1ST COA SUBMITTAL

56TH & PICADILLY MARKETPLACE
OFFSITE IMPROVEMENT SITE PLAN

SITE PLAN

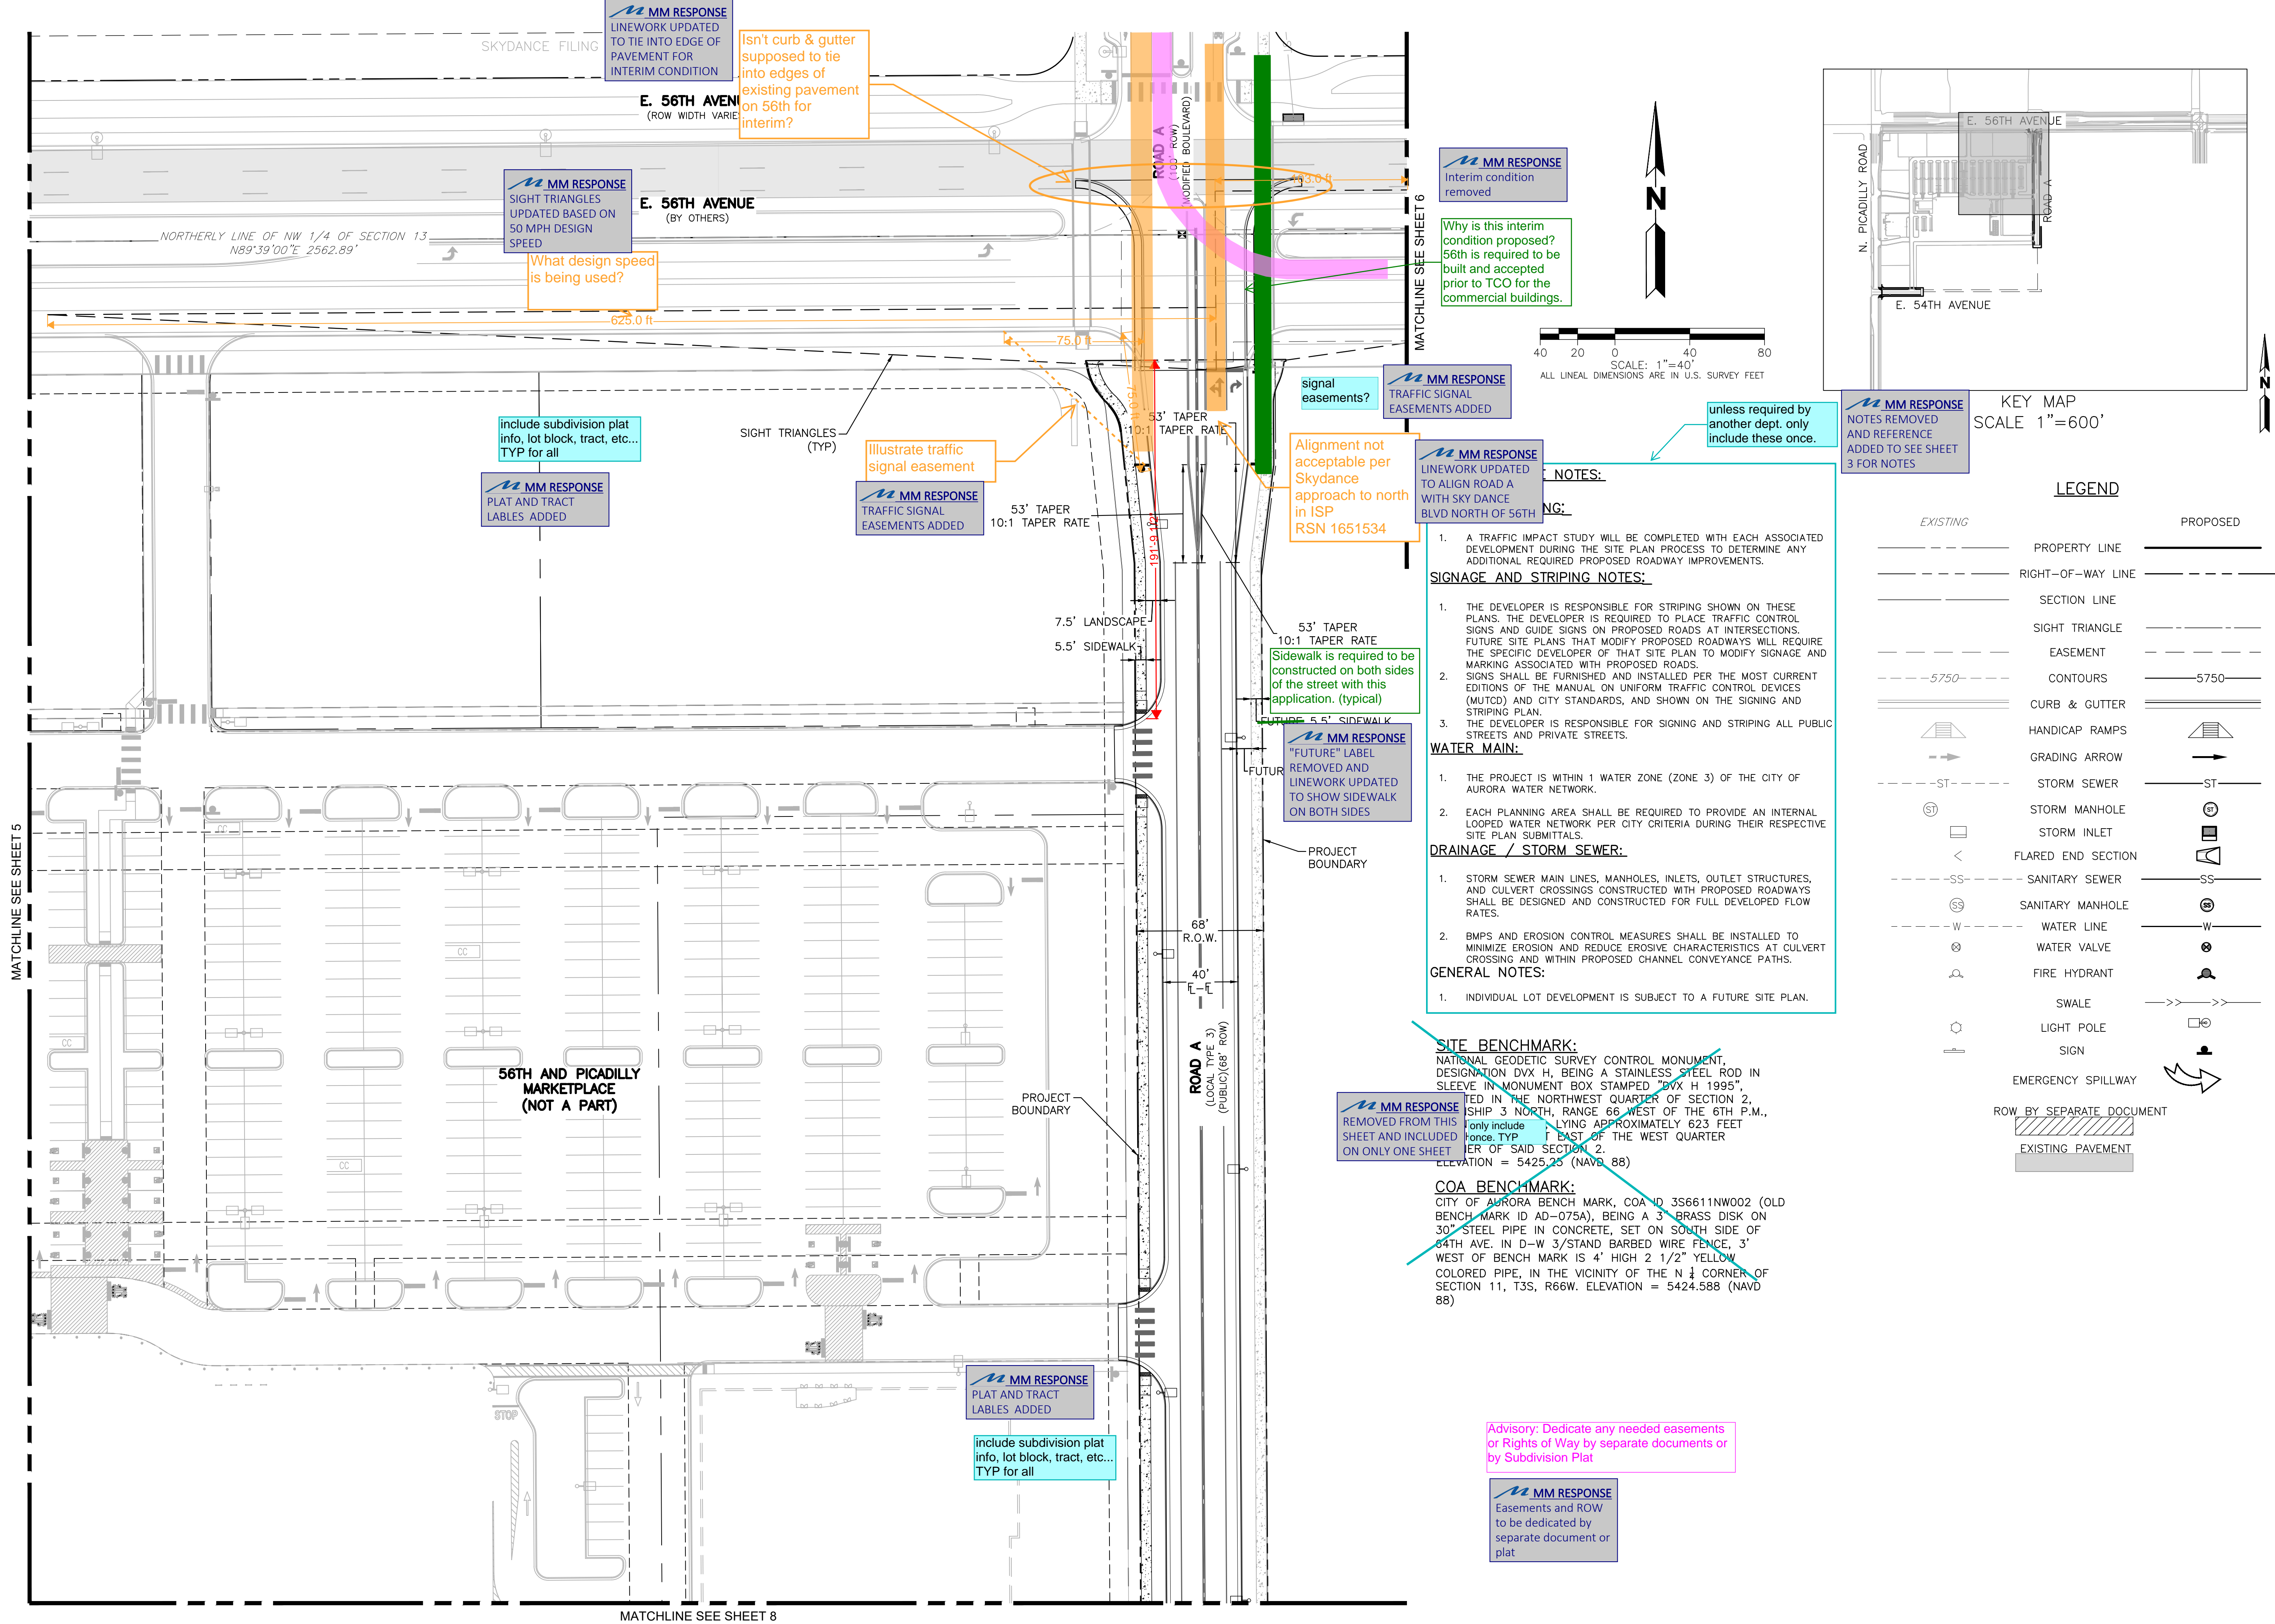
what is included in Hard surface area? What about sidewalks not being constructed?

Provide the case numbers for 56th and Picadilly. They are required to be approved, constructed, and accepted prior to issuance of TCO for the commercial buildings.

add lots, blocks, title of proposed plat. TYP for whole site

PER the presubmittal meeting, 56th was not included. Please explain why it is shown and update LOI

show ex/Prop ROW and tie-in

get the name of this street from Phil Turner

Reference Denver
Add zone district
UNPLATTED

show ROW and tie-in

show COA boundary
Label City and County of Denver for west side of Picadilly

Reference adjacent site plans, ISPs and include case numbers

Does the south half of 54th Ave include Clayton Properties land?

add note:
Future Access

Add zone district
UNPLATTED

add note:
Future Access

add note:
Future Access

MM RESPONSE
 Future sidewalks to be included. "Future" removed from the call out

MM RESPONSE
Noted, 56th ISP to be submitted separately but at the same time as this project, once DA and Case numbers added those labels to be included

MM RESPONSE
Lot labels added based on Green Valley Ranch Plat received from KS from 12/11/2024

MM RESPONSE
Updated to remove sheets 6 & 12 from the set now that 56th Ave is by separate project submitted separately

MM RESPONSE
ROW shown with tie-in to 56th ave.

MM RESPONSE
We will send an email and coordinate with Phil Turner on the road name.

MM RESPONSE
Label added for Denver Reference

MM RESPONSE
ROW shown with existing 132' label. Linework turned on and tie in updated for flowline.

MM RESPONSE
Label added for Denver
Reference to plat and zoning

MM RESPONSE
ISP and case numbers added for Picadilly, place holder shown for 56th ave since that is being submitted at same time, 56th & Picadilly Marketplace added.

Please provide adjacent project to the south of 54th ave for the Clayton property and we will add it to the plans, thanks!

MM RESPONSE
note/label added for future access

MM RESPONSE
UPLATTED LABEL ADDED AND ASSUMED ZONE A.
PLEASE CONFIRM NEIGHBORING PROJECT

MM RESPONSE
note/label added for future access

MM RESPONSE
note/label added for future access

Design Project No.	24.1527
Drawing Title	GRADING AND UTILITY PLAN
Drawing No.	10

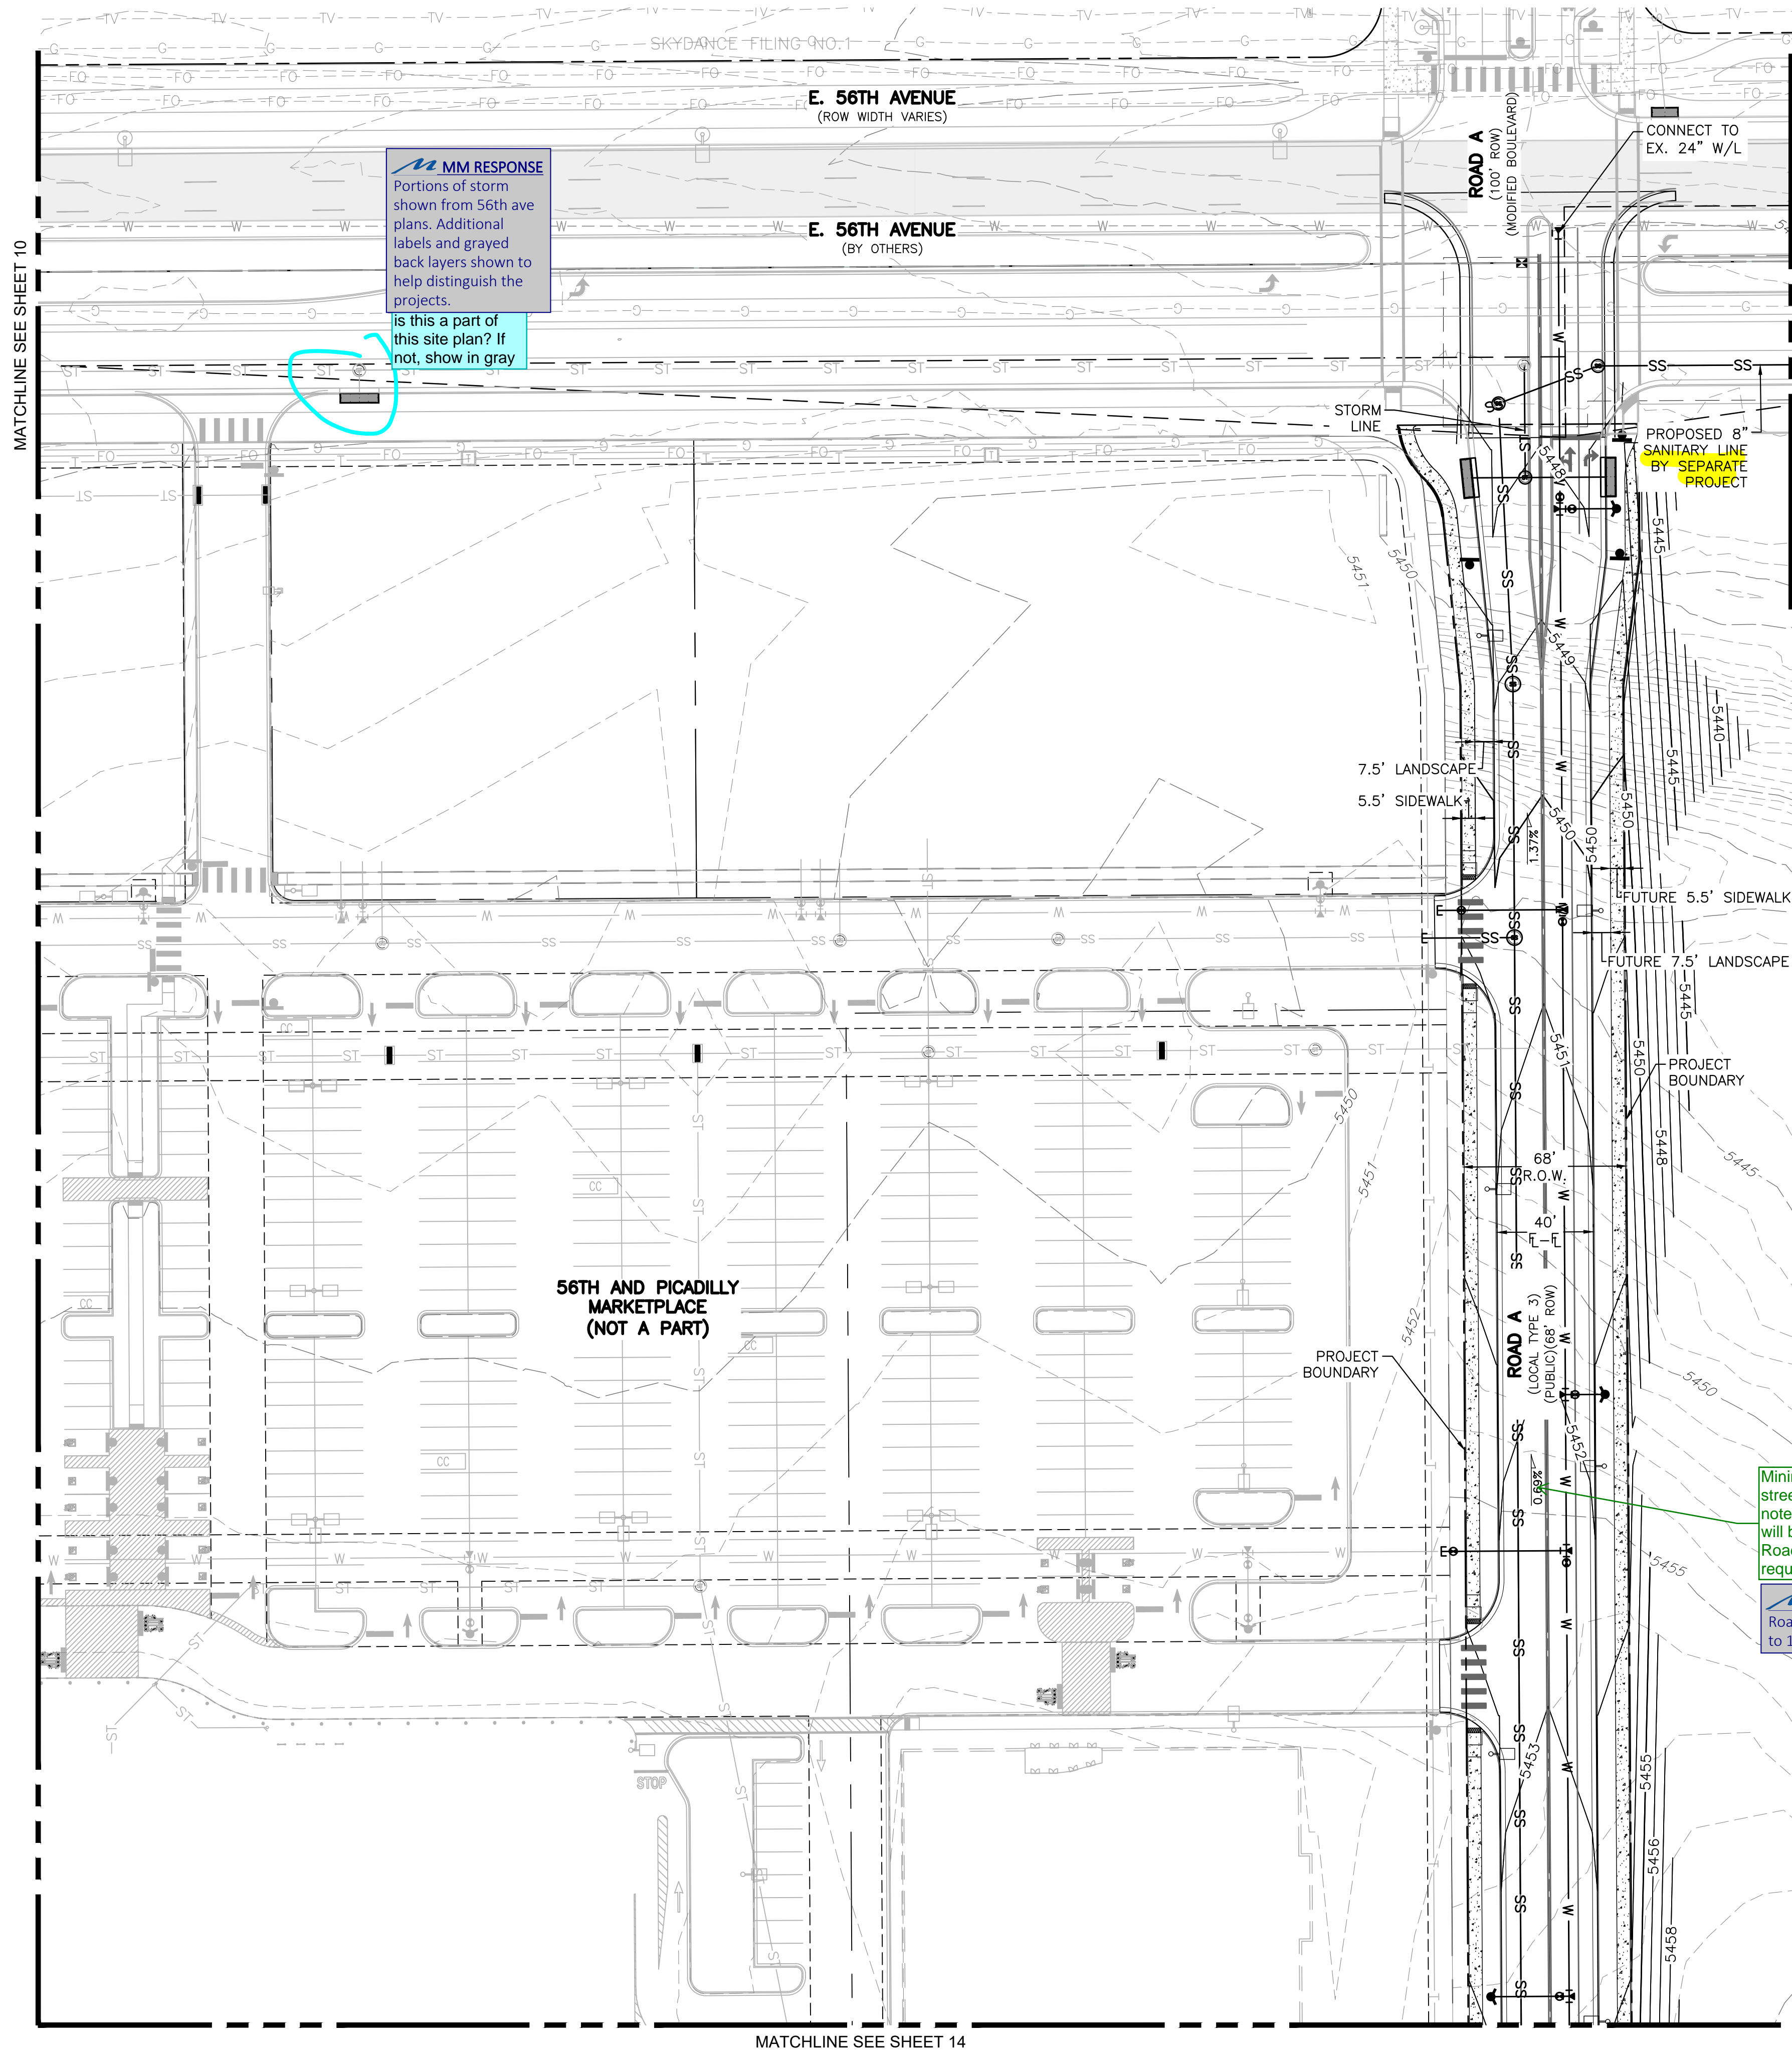
Please indicate the No Parking Area delineated by a 15 foot measurement to either side of the hydrant and the required No Parking Signs.

MM RESPONSE
No parking signs added near the FH.
